NOTICE OF ISSUANCE OF AMENDMENT TO FACILITY OPERATING LICENSES

ATTACHMENT TO LICENSE AMENDMENT NO. 5
CHANGE NO. 10 TO THE TECHNICAL SPECIFICATIONS
FACILITY OPERATING LICENSE NO. DPR-24
DOCKET NO. 50-266

SAFETY EVALUATION BY THE OFFICE OF NUCLEAR REACTOR REGULATION
SUPPORTING AMENDMENT NOS. 5 AND 9 TO LICENSE NOS. DPR-24 AND DPR-27
(CHANGE NOS. 10 AND 15 TO THE TECHNICAL SPECIFICATIONS)

POINT BEACH NUCLEAR PLANT, UNITS 1 AND 2

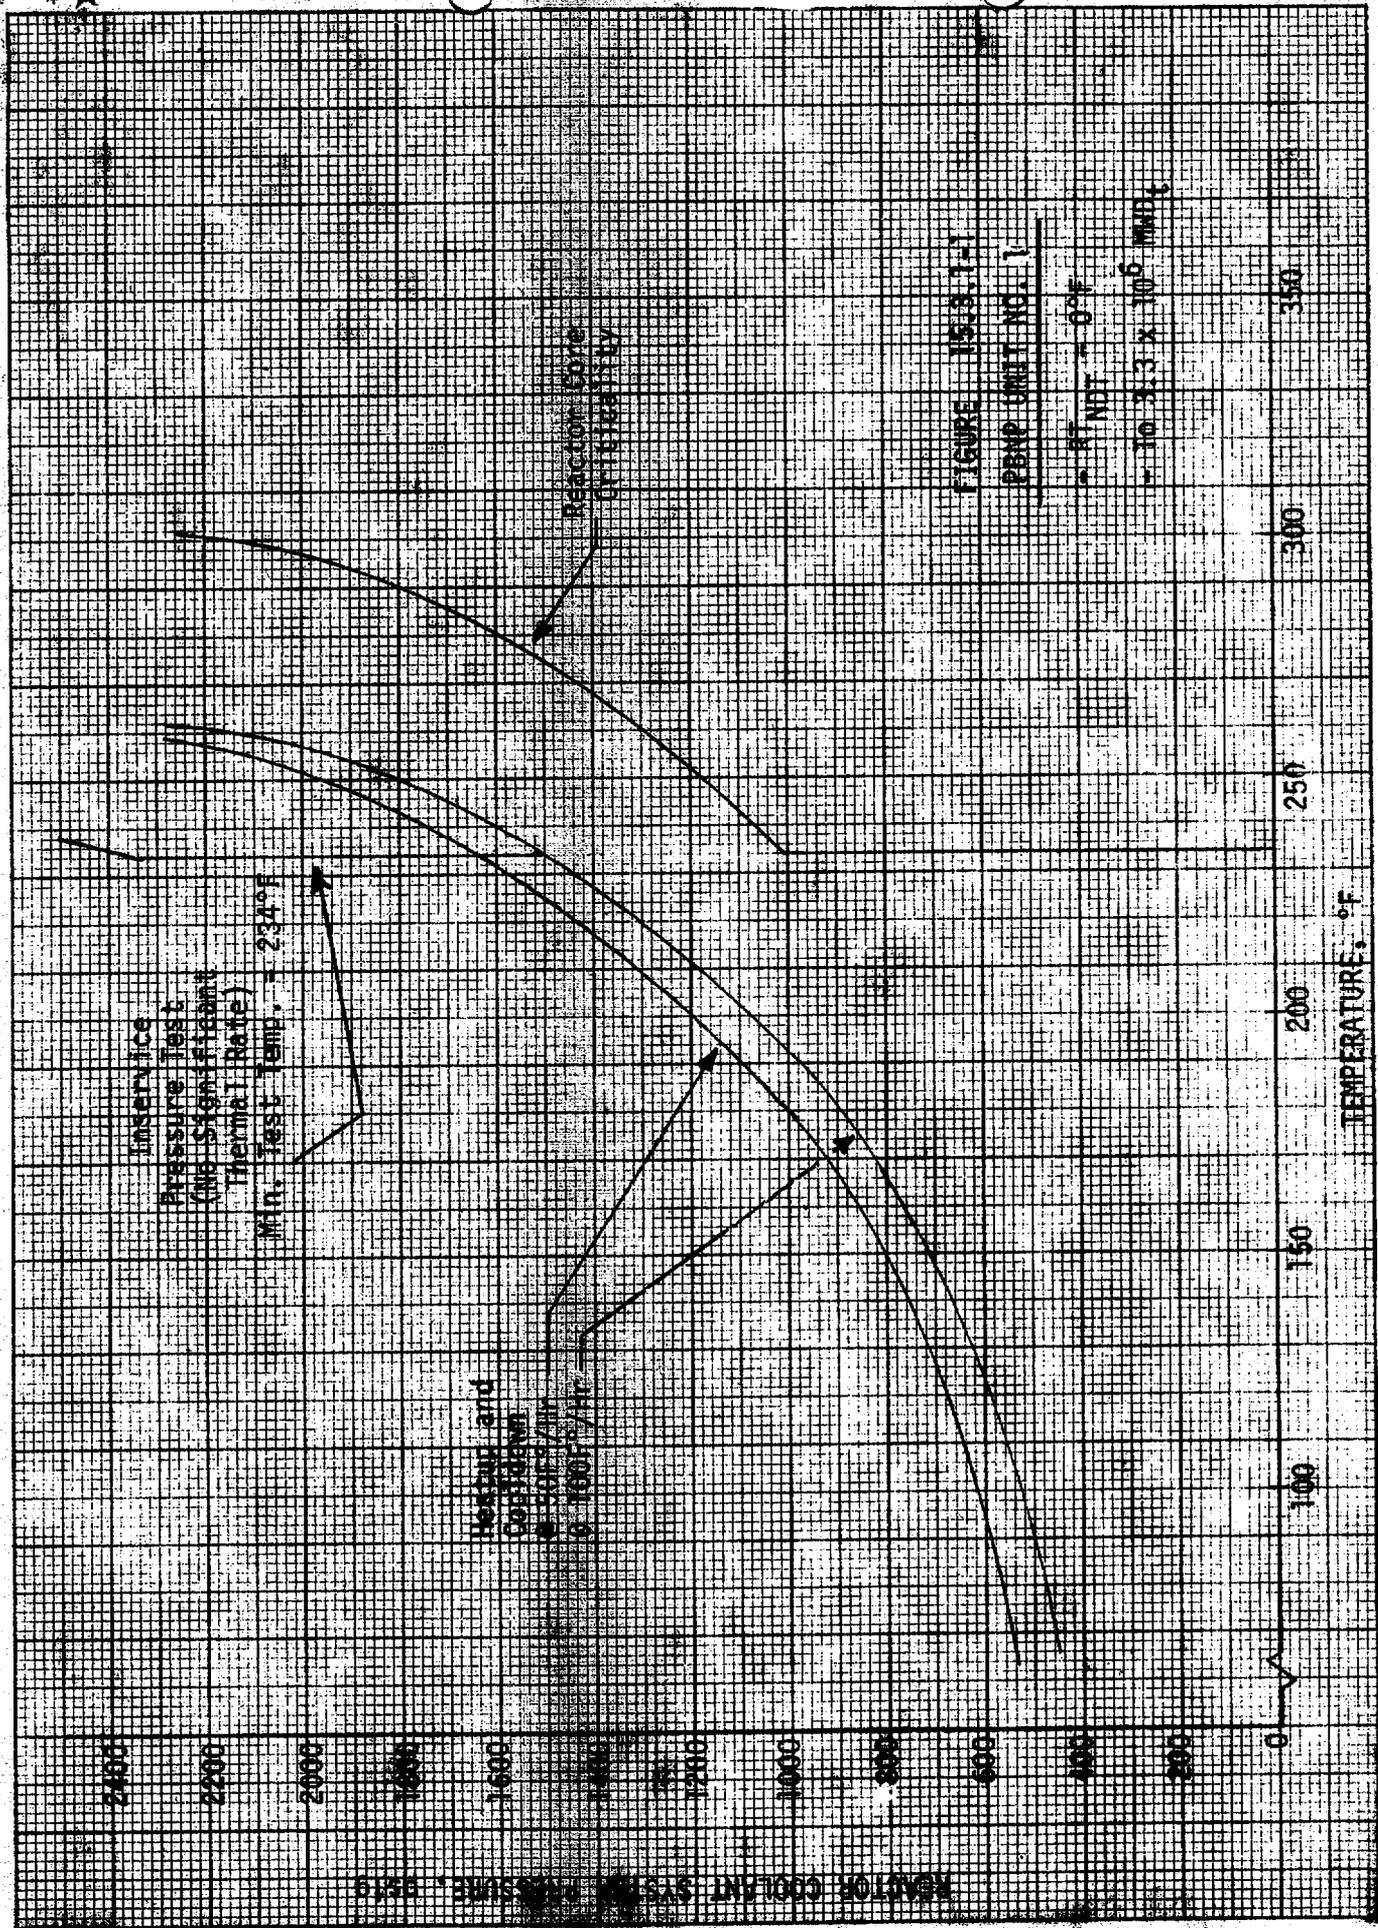
Replace pages 15.3.1-3, 15.3.1-4 through 15.3.1-8 and 15.3.1-17 and 15.3.1-18, and Figure 15.3.1-1 with the attached revised pages. (No change made on page 15.3.1-3.)

1. The Reactor Coolant System temperature and pressure shall be limited in accordance with the limit lines shown in Figure 15.3.1-1 (Unit 1) during heatup, cooldown, criticality, and inservice leak and hydrostatic testing with:

The heatup and cooldown curves presented in Figure 15.3.1-1 (Unit 1) were calculated based on the above information and the methods of ASME Code Section III (1974 Edition) Appendix G, "Protection Against Nonductile Failure" and are applicable up to the operation exposure indicated on the figures.

The pressure-temperature limit lines shown on Figure 15.3.1-1 for reactor criticality and for inservice leak and hydrostatic testing have been provided to assure compliance with the minimum temperature requirements of Appendix G to 10 CFR 50 for reactor criticality and for inservice leak and hydrostatic testing.

The pressure-temperature limits defined for hydrostatic leak tests (Figure 15.3.1-1 for Unit 1 and Figure 15.3.1-2 for Unit 2) were determined in a similar manner as the limits discussed above and in accordance with the ASME Code. In this case, however, there was no need for consideration of the thermal gradient stress intensity factor because no significant metal heatup or cooldown occurs during the hydrostatic test. We have reviewed the proposed limits and conclude that they meet the requirements of Appendix G to 10 CFR Part 50; and therefore are acceptable.

The proposed limits (Figure 15.3.1-1 for Unit 1 and Figure 15.3.1-2 for Unit 2) were derived using methods described earlier with additional safety factors required by Appendix G to 10 CFR Part 50. These additional factors include the temperature for criticality (equal to that of hydrostatic test) and an additional 40°F temperature increase beyond the operating pressure-temperature limits discussed earlier. We have reviewed the basic test data, the analytical techniques and the resultant limits and conclude that they meet the requirements of Appendix G to 10 CFR Part 50; and therefore are acceptable.

FIGURE 15.3.1-2
PUMP UNIT NO. 2

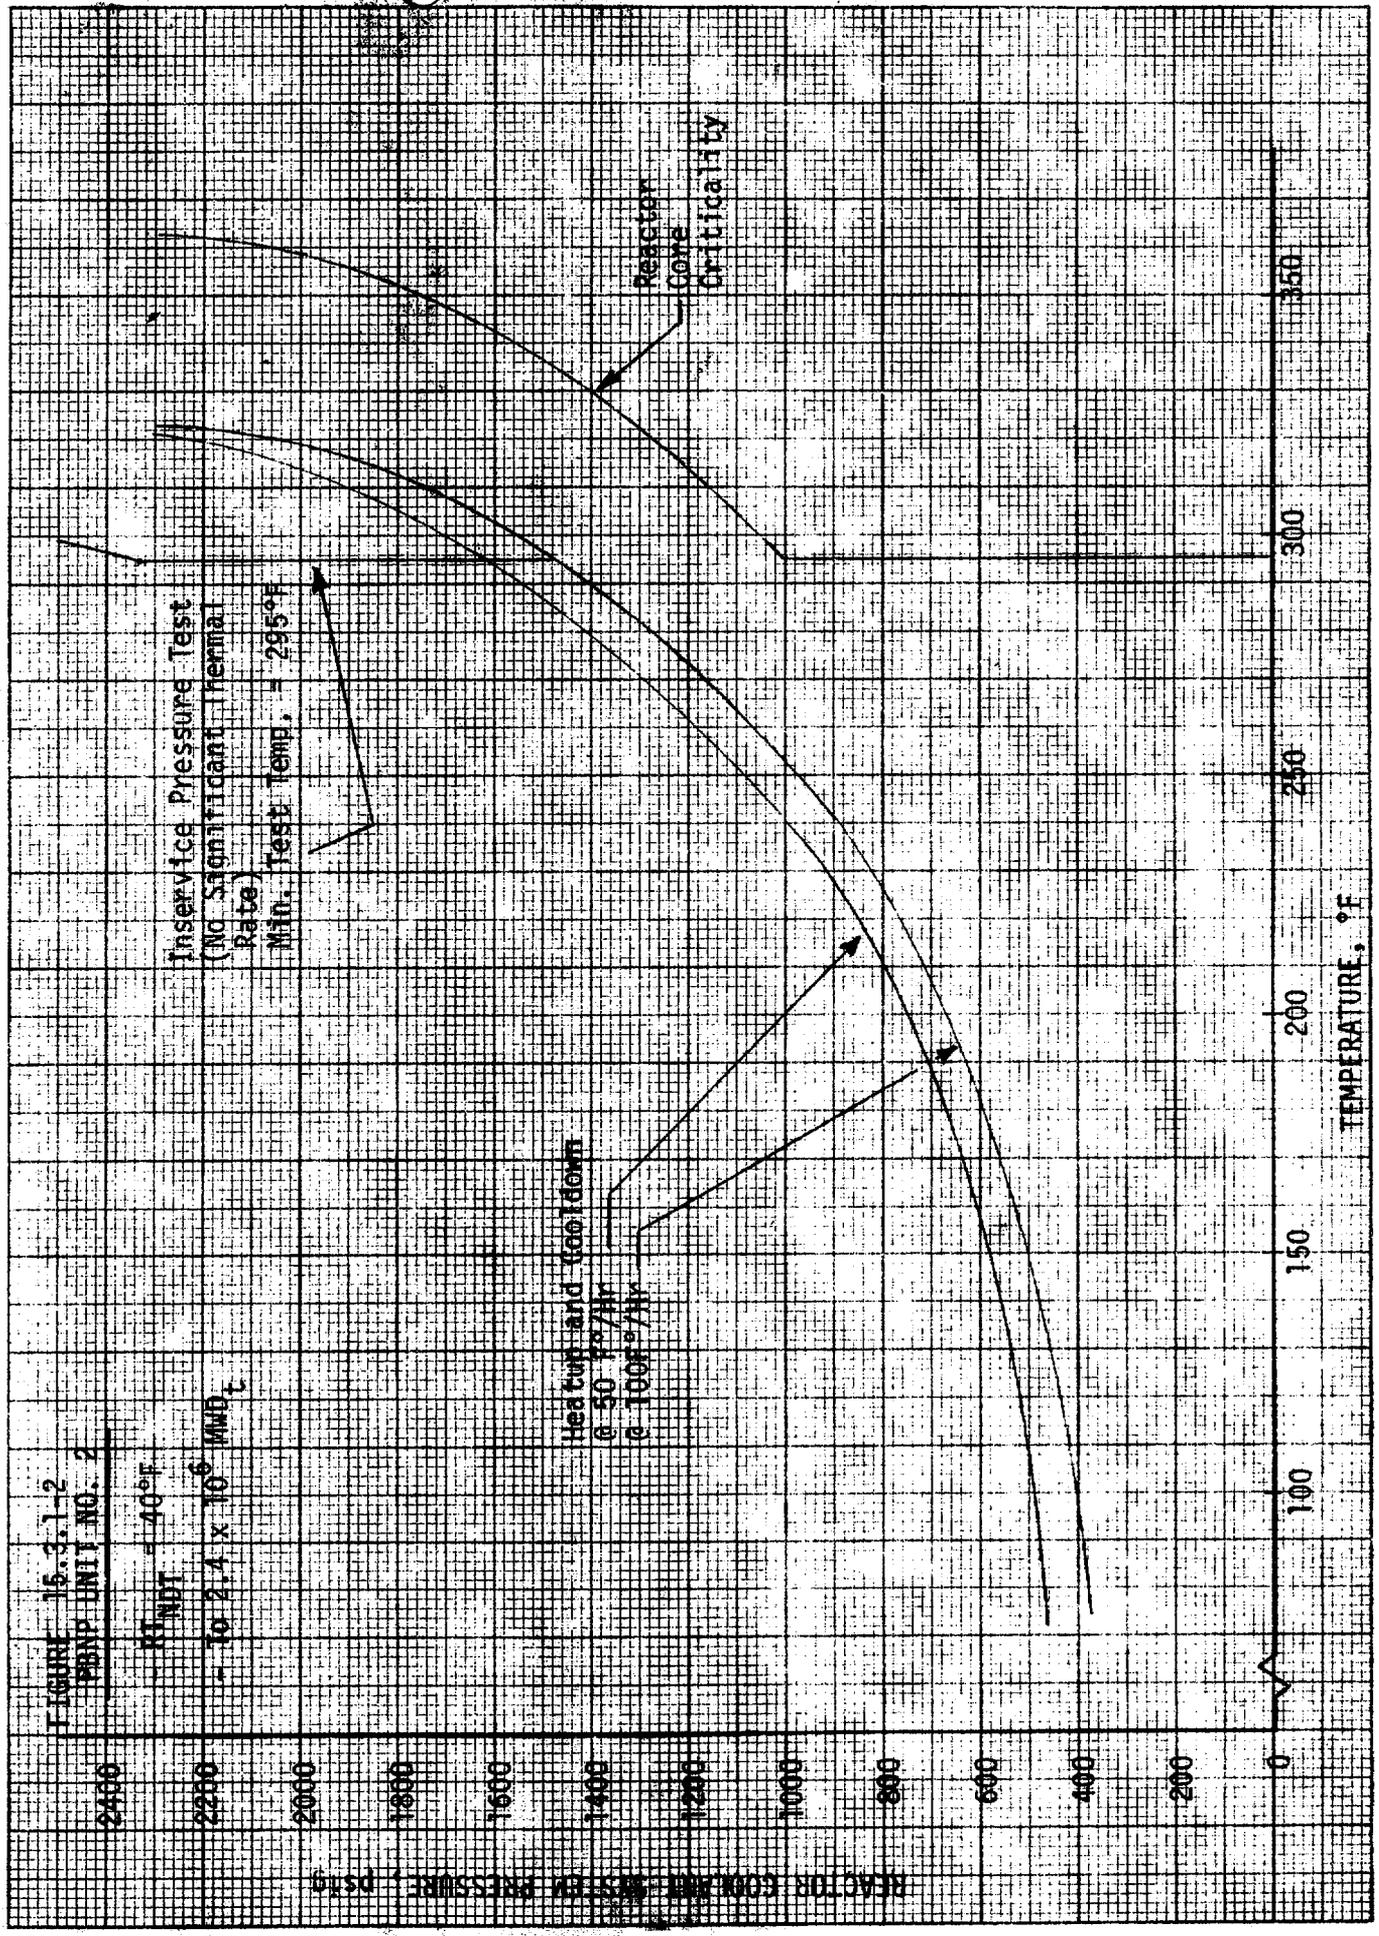
Replace pages 15.3.1-3, 15.3.1-4 through 15.3.1-8 and 15.3.1-17 and 15.3.1-18, and Figure 15.3.1-2 with the attached revised pages. (No change made on page 15.3.1-3.)

1. The Reactor Coolant System temperature and pressure shall be limited in accordance with the limit lines shown in 15.3.1-2 (Unit 2) during heatup, cooldown, criticality, and inservice leak and hydrostatic testing with:

The heatup and cooldown curves presented in Figure 15.3.1-2 (Unit 2) were calculated based on the above information and the methods of ASME Code Section III (1974 Edition) Appendix G, "Protection Against Nonductile Failure" and are applicable up to the operation exposure indicated on the figures.

The pressure-temperature limit lines shown on Figure 15.3.1-2 for reactor criticality and for inservice leak and hydrostatic testing have been provided to assure compliance with the minimum temperature requirements of Appendix G to 10 CFR 50 for reactor criticality and for inservice leak and hydrostatic testing.
